**RICHFIELD LIVING
CAMPUS
REDEVELOPMENT
PART 2
SALEM, VA**

PHASE 1-GRADING & STORM DRAINAGE PLAN-SOUTH

Issues and Revisions:
10/15/2018 1ST SITE SUBMITTAL
11/09/2018 PERMIT SET
12/19/2018 PER 1ST SITE REVIEW
12/19/2018 CONSTRUCTION SET
04/02/2019 ADDENDUM 2

C5.2

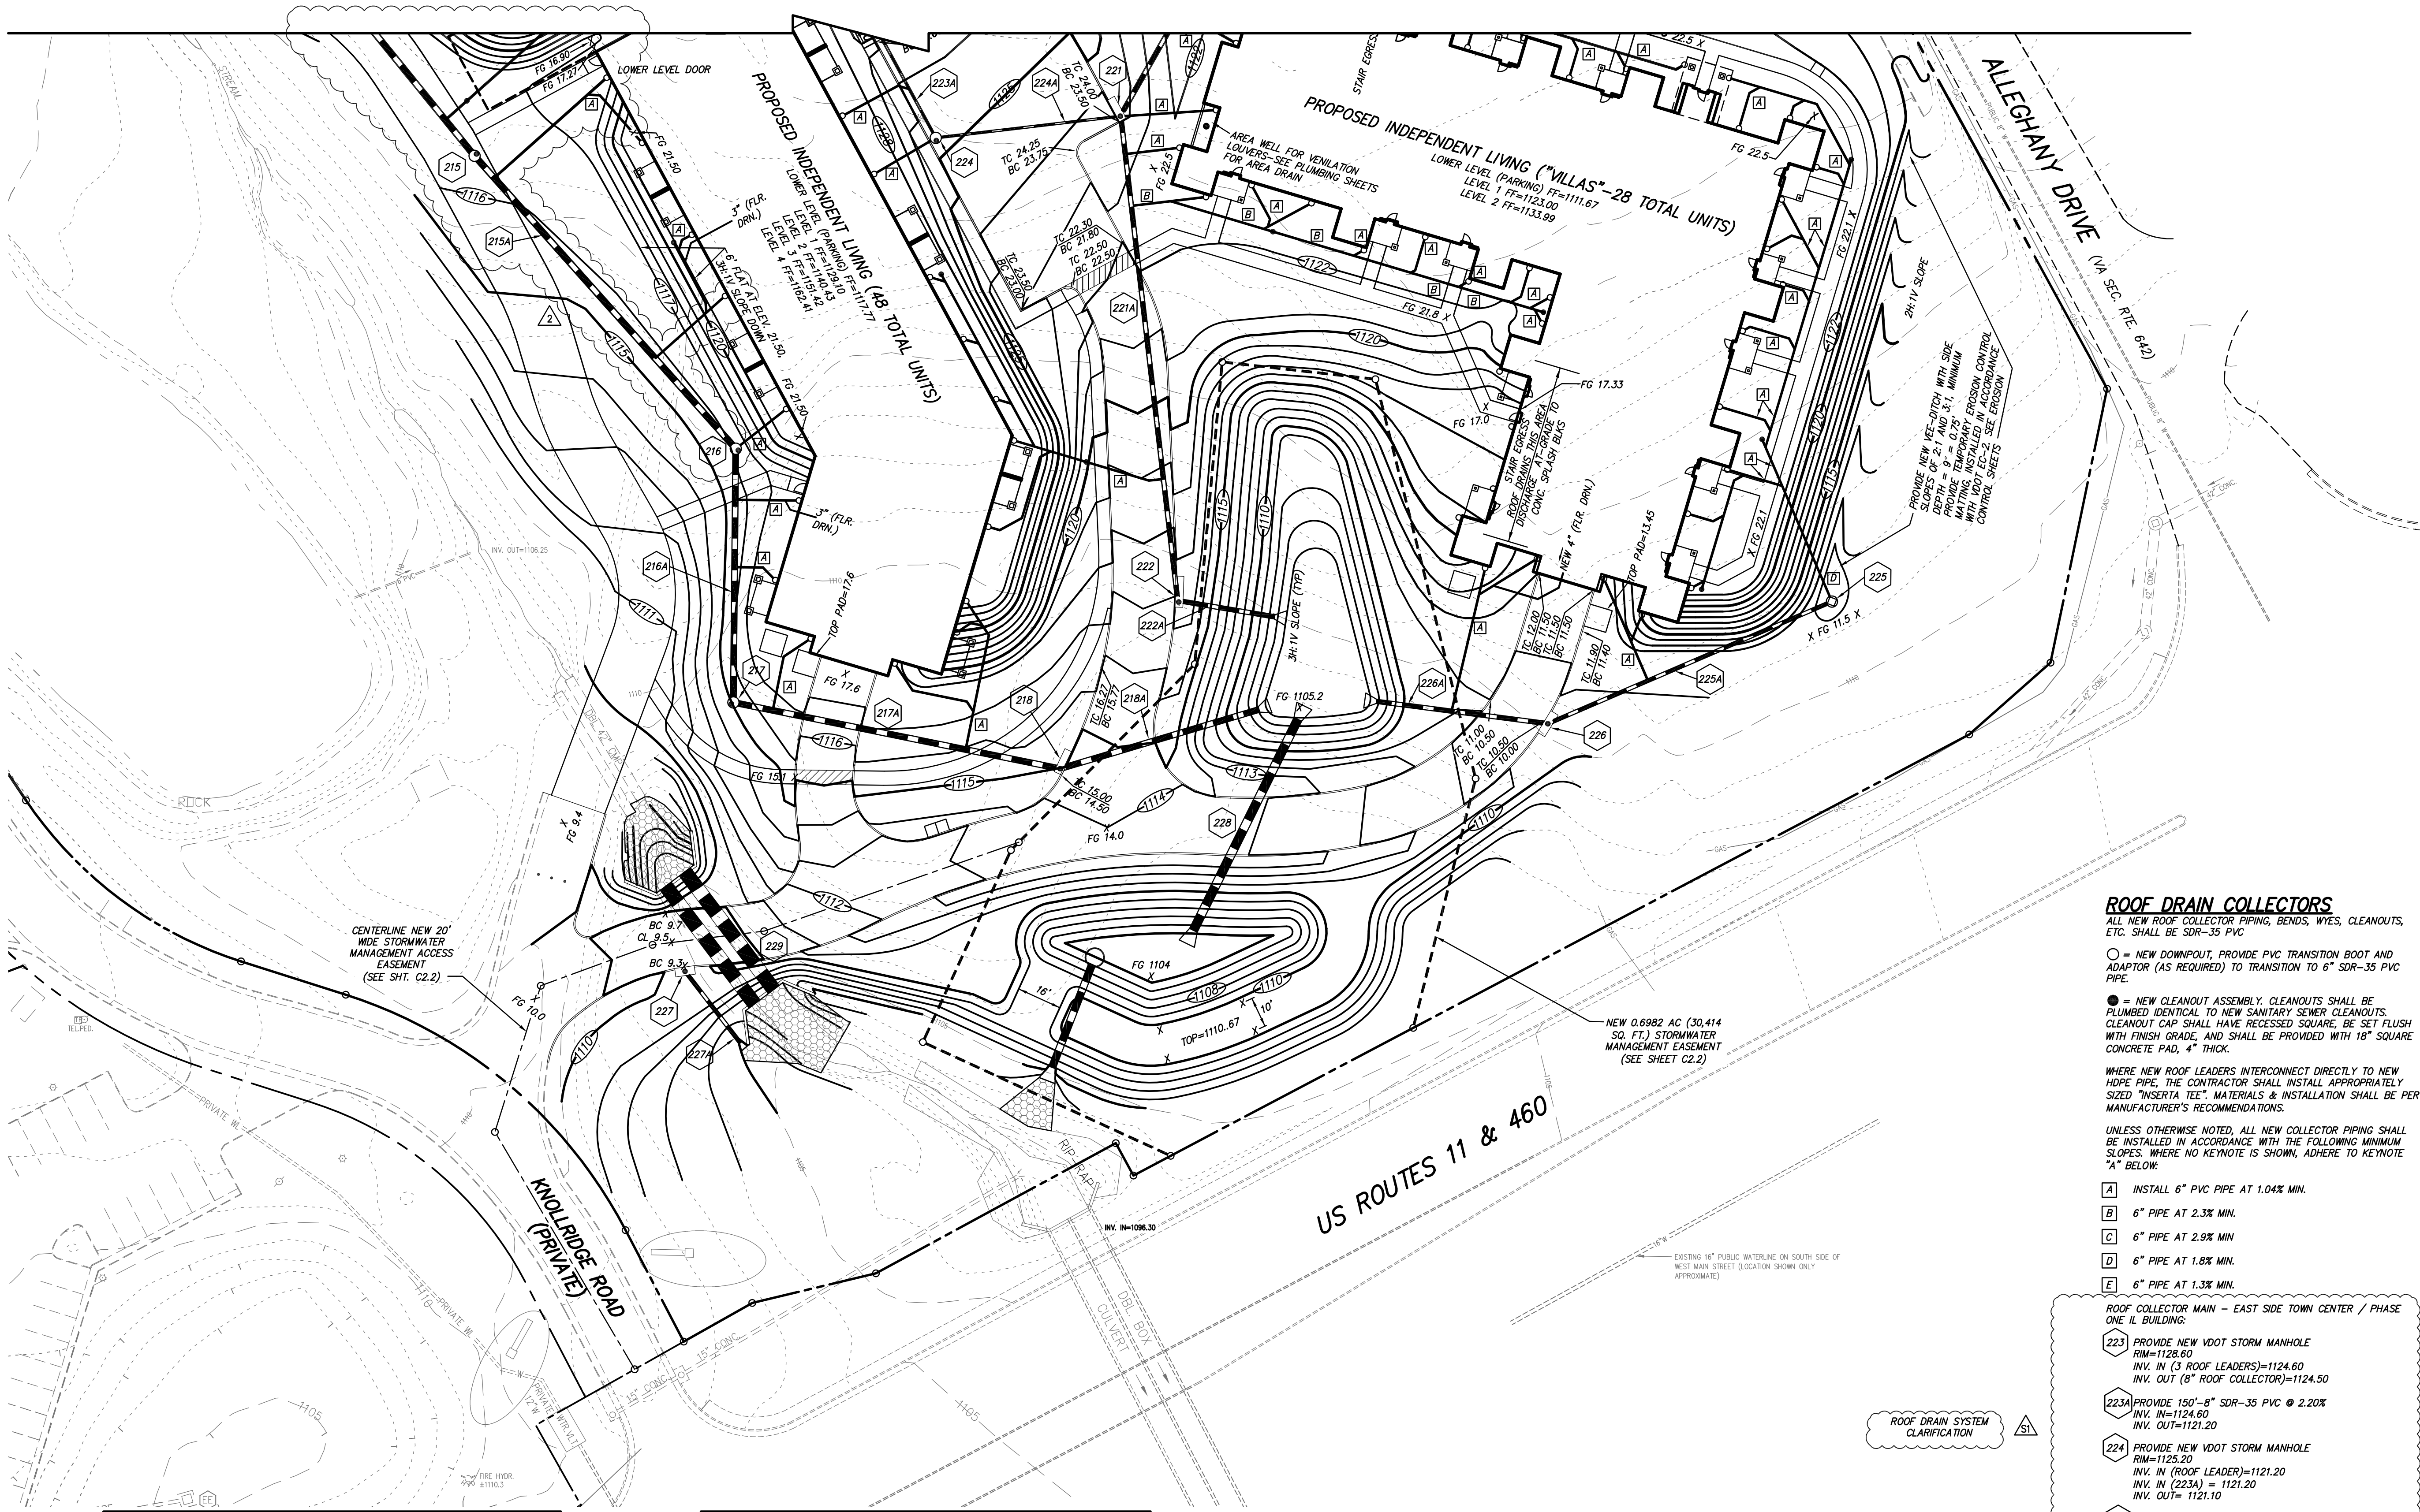
ROOF COLLECTOR MAIN - EAST SIDE TOWN CENTER / PHASE ONE IL BUILDING:

223 PROVIDE NEW VDOT STORM MANHOLE
RIM=1128.60
INV. IN (3 ROOF LEADERS)=1124.60
INV. OUT (8" ROOF COLLECTOR)=1124.50

223A PROVIDE 150"-8" SDR-35 PVC @ 2.20%
INV. IN=1124.60
INV. OUT=1121.20

224 PROVIDE NEW VDOT STORM MANHOLE
RIM=1125.20
INV. IN (ROOF LEADER)=1121.20
INV. IN (223A) = 1121.20
INV. OUT= 1121.10

223A PROVIDE 65"-8" SDR-35 PVC @ 2.20%
INV. IN = 1121.10
INV. OUT = 1119.67

ROOF DRAIN SYSTEM CLARIFICATION
